REQUEST FOR INFORMATION (RFI)

RFI No.: ABF-RFI-003244R00 **Submitted By:** OSullivan, Bill **Pages:** 1
Pages Attached: 0

Subject: System Ground, West Girder to Tower			
References:			
Sub/Sup: BLI	**Sub RFI #:** RFI-BLI-174		
Response Required by: 10-April-2013		**Response affects critical path activity?** Yes

Project: 04-0120F4 - SAS

SK-RFI3244R00-E97
Adil M. 4/3/13

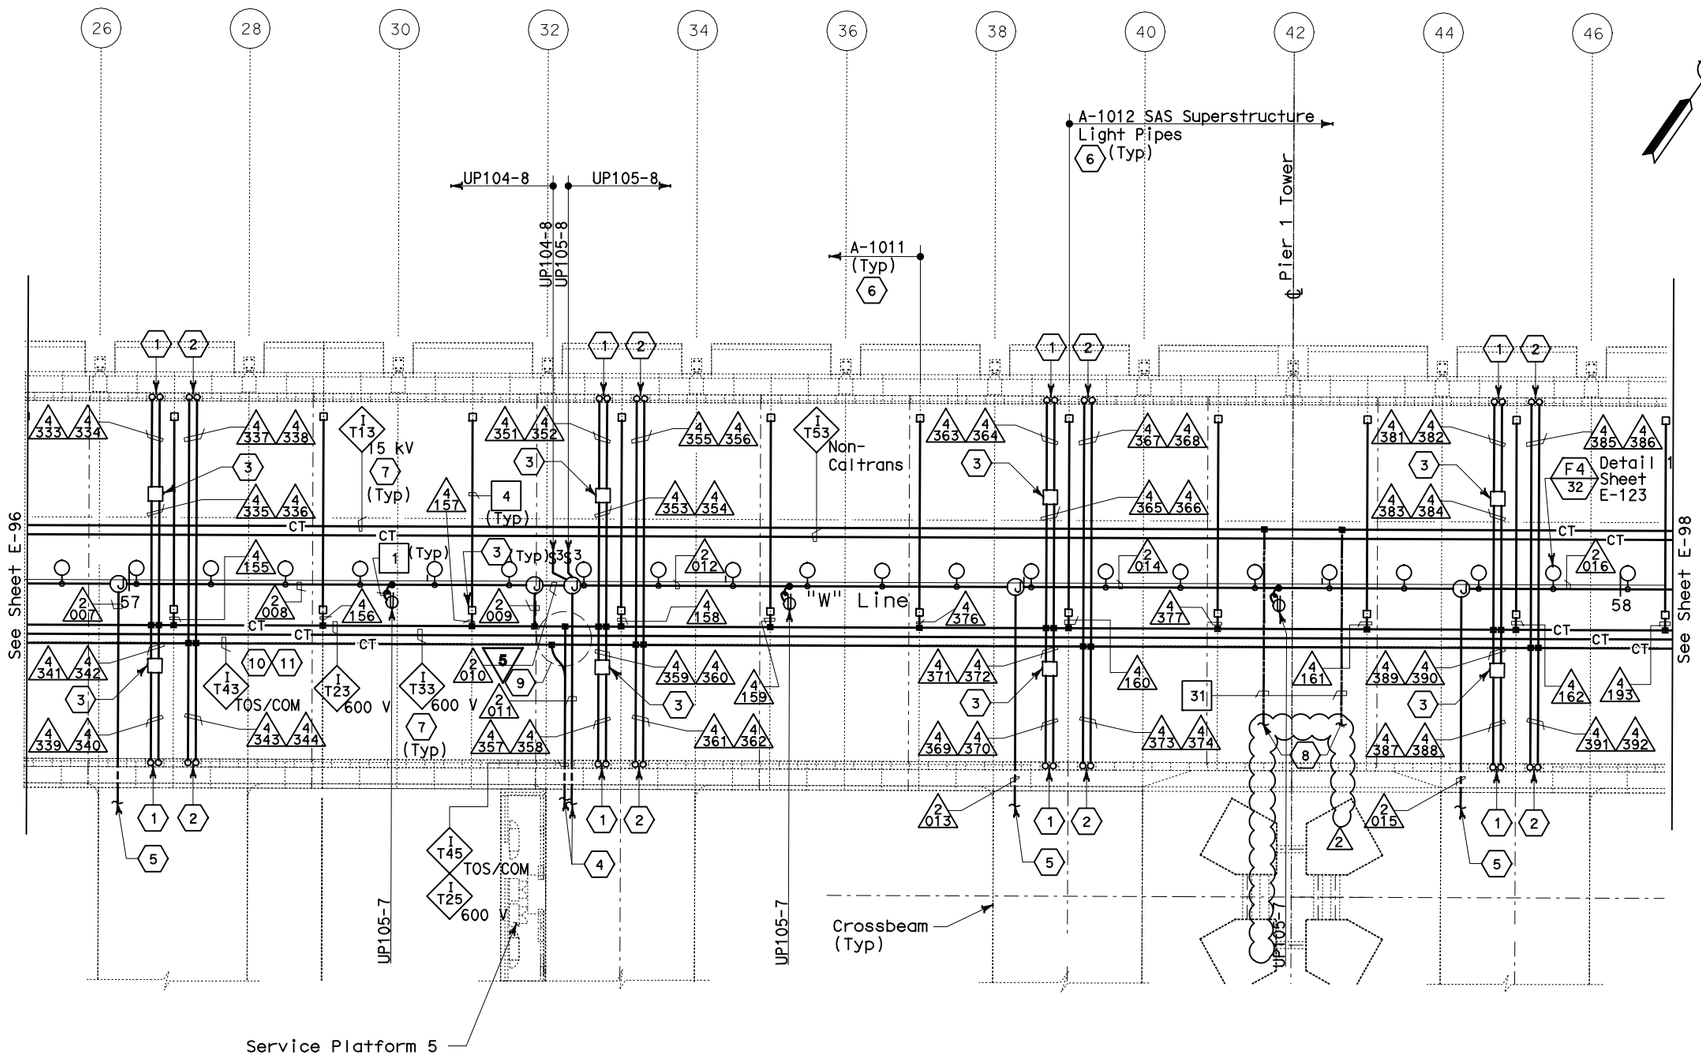
Please issue the alternate detail for conduit support for the system ground on the D face of the NE quadrant of the tower; include the conduit change from 27C to 41C. Thank you.

Also attached are sketches SK-RFI3244R00-E97, SK-RFI3244R00-E111A and SK-RFI3244R00-E264F-1 reflecting the change in conduit size from 27C to 41C as requested by the Contractor.

Sketches SK-RFI3244R00-E97, SK-RFI3244R00-E111A and SK-RFI3244R00-E264F-1 are also attached reflecting the change in the conduit size from 27C to 41C as requested by the Contractor.
